NUMBER 84

BULLETIN

SUBJECT: Winterization of J3C-65

MODELS AFFECTED: J3C-65 Airplanes

FIG I

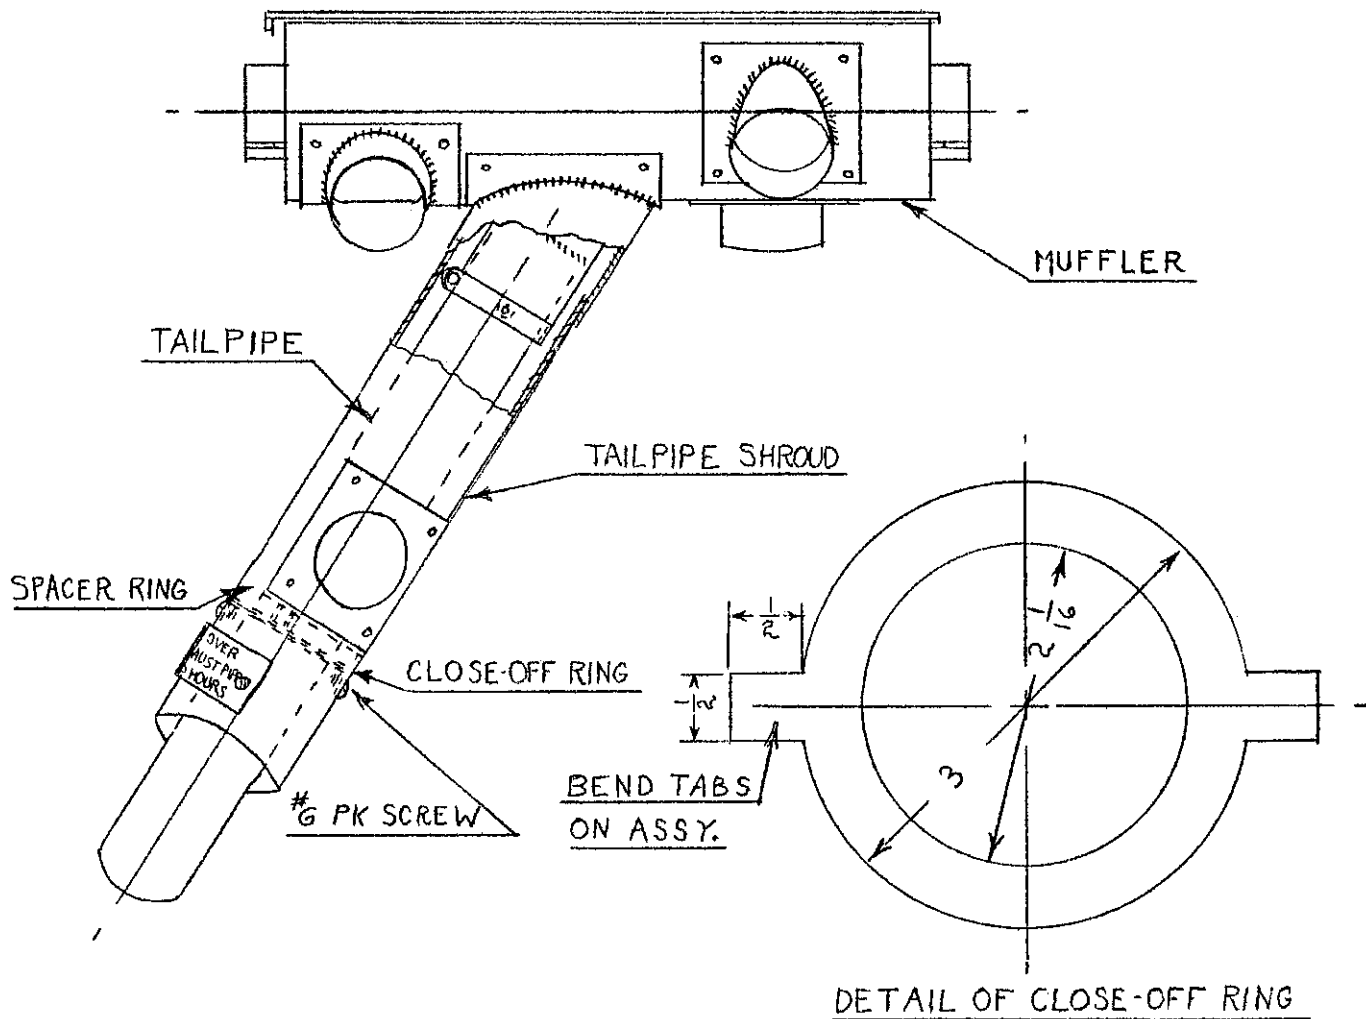
1. All J3C-65 airplanes, with muffler installation, up to serial number 15396.
 - a. The aluminum breather tube (Part No. 84332) can be lagged with 1/16" to 1/8" felt or some similar material which should extend all the way to the bottom of the tube.

- b. To obtain a higher operating oil temperature, it is permissible to lag the oil sump with waterglass and flake asbestos or some similar material which will keep the cold air off the sump and hold the heat in. A material thickness of 1/16" to 1/8" is satisfactory for this lagging.

- c. The cowl air inlet opening, the first opening under the propeller hub, should be closed. Piper Part 73951 is a cover plate for this opening.
 - d. In order to insure the highest possible carburetor heat rise, the flat plate valve in the carburetor air box should be checked to see if it is seating properly. This can be done easily by removing the air filter and observing the top edge of the valve, with heat on. The valve should seat flush with the top of the box, with absolutely no air gap.

- e. The tailpipe shroud assembly (Part No. 70912) can be lagged with asbestos or some similar fireproof material. The recommended thickness of this material is approximately 1/16".

f. The flexible tube which runs from the tailpipe shroud to the carburetor air box can also be lagged with the same material as used on the tailpipe shroud.

g. See Figure I.
